Re: Liam O'Neill P1212-01

I refer to previous Agency correspondence of 4th November last. Please find detailed below the response to the issues raised.

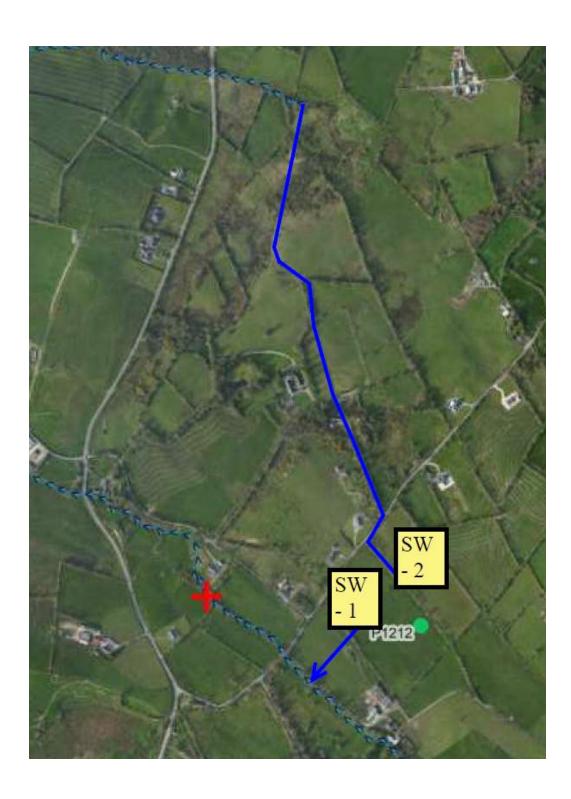
b. The stormwater lines after Attenuation Tank 1 and 2 appear to indicate a discharge to ground as they are not connected to field drains or a watercourse on the site plan provided. However, the licence application states that their receiving environment is the Dromore 40 waterbody.

Provide a site plan that outlines the full surface water pathways with continuous lines between the storm water discharge points and the local land drains/watercourses or to ground.

As detailed on the site plan;

- SW 2 discharges to a piped field drain.
- SW 1 piped drain to open watercourse has been detailed.

Full surface water pathway as per previously detailed and as shown below.
